VLA Expansion Project  
Antenna Electronics  
Block Diagram (w/ VLITE)

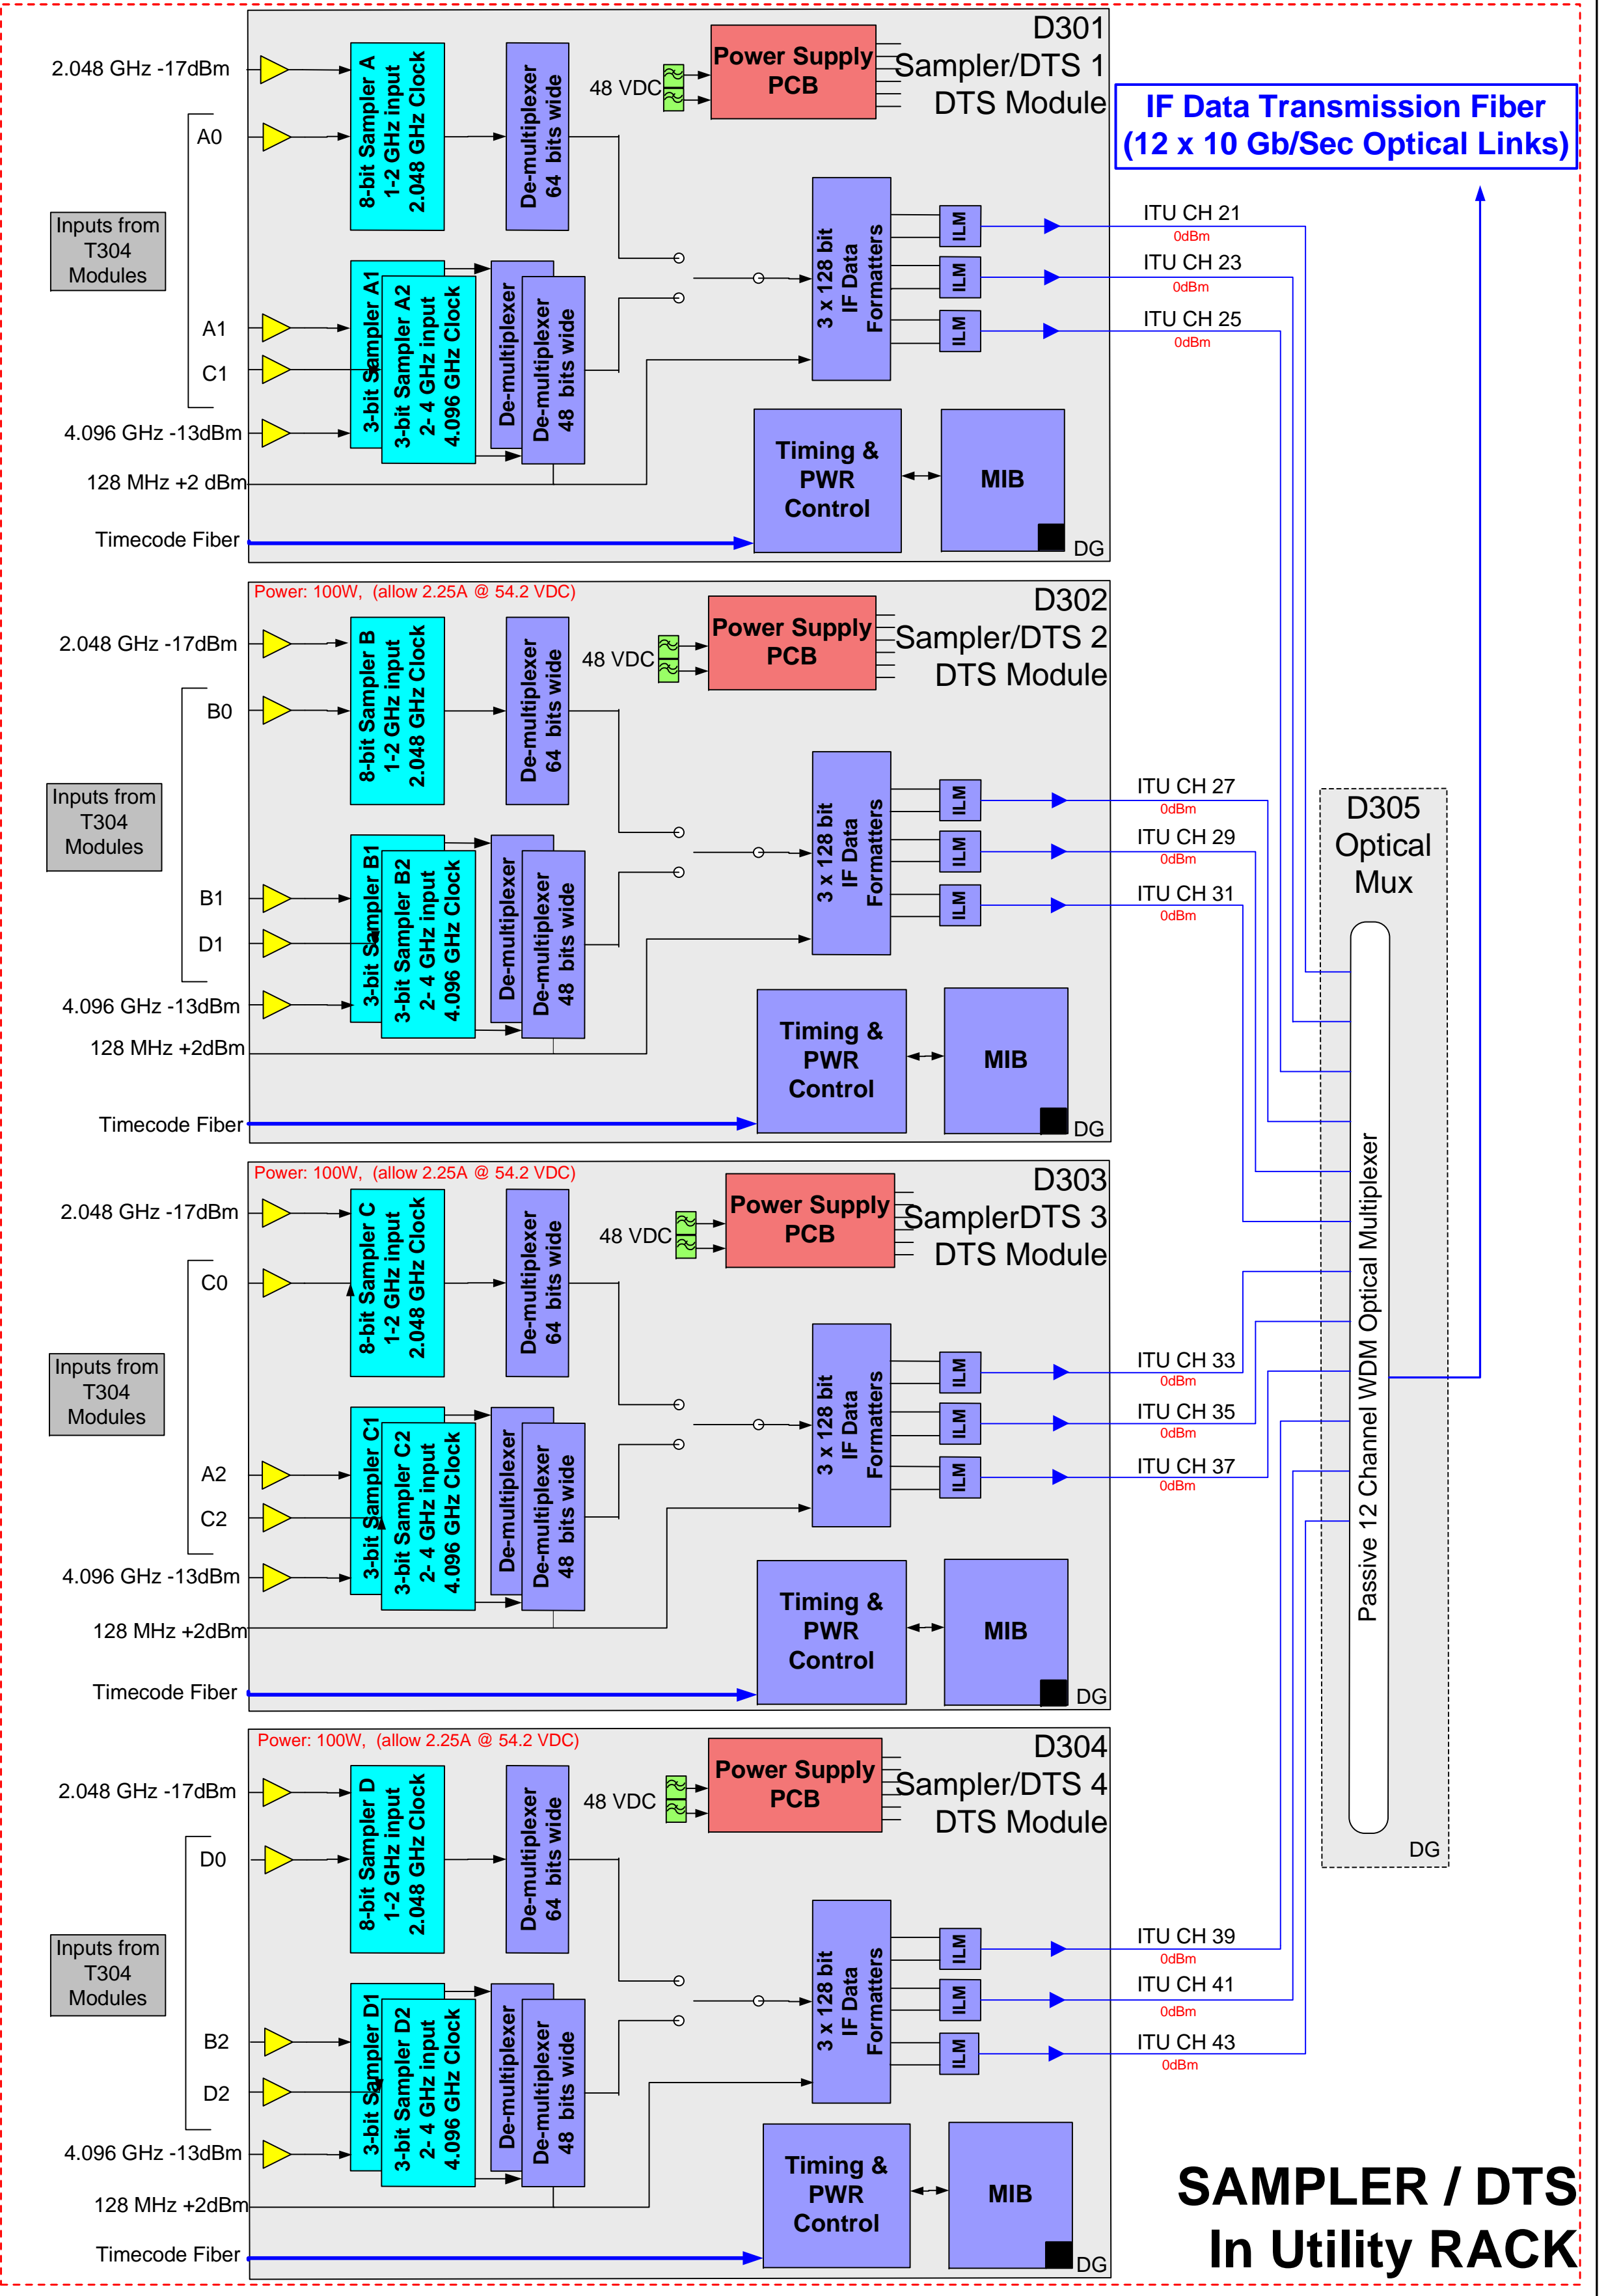
Changes made 18 Oct 2013, JJ :  
- Added D306 VLITE Module  
- Added Optical Splitter for D306 Timecode  
- Added Splitter to L300 for 1.024 GHz Clock to D306  
- Added Splitters to Low Band Receiver Output for D306  
- Removed F14 Modules (no longer needed)  
- Modified F320 for Low Band Receiver Control (renamed F318)  
- General drawing cleanup.
